Position paper

on 2025 IGC Plenary agenda item 6.2.11 "[New Turn Point Geometry](#)", Year 1 proposal by France and Germany

submitted by Swedish IGC delegate Reno Filla

January 28th, 2025

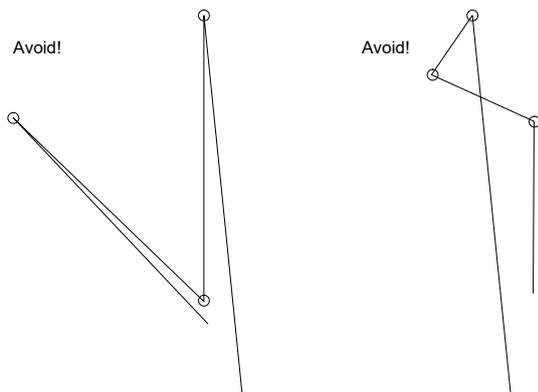
However, the now proposed change of the observation zone will likely have a much greater impact, as now the penalty for deviating from the original task leg becomes smaller since the leg no longer has to connect to the original turn point. The discussion has so far focused on bad weather, but who will prevent such “turn point optimization” from happening when there is an advantage to be gained from exceptionally good local weather, instead? Pilots can actually become encouraged to find other paths towards rounding the turn points, perhaps following a ridge or a cloud street far longer than what would otherwise have been practical, which then might put them onto a collision course with their competitors who have chosen another path. This will be discussed in more detail below.

Giving the pilots the opportunity and incentive to choose their own turn point within the large observation zone behind the original turn point will significantly increase the likelihood of (near-) collisions, as pilots can meet head-on or cross paths perpendicular in an area and at a time where the cognitive workload is already high, not the least due to possibly bad weather. Safety comes also from predictability, which the proposed change of observation zone greatly reduces.
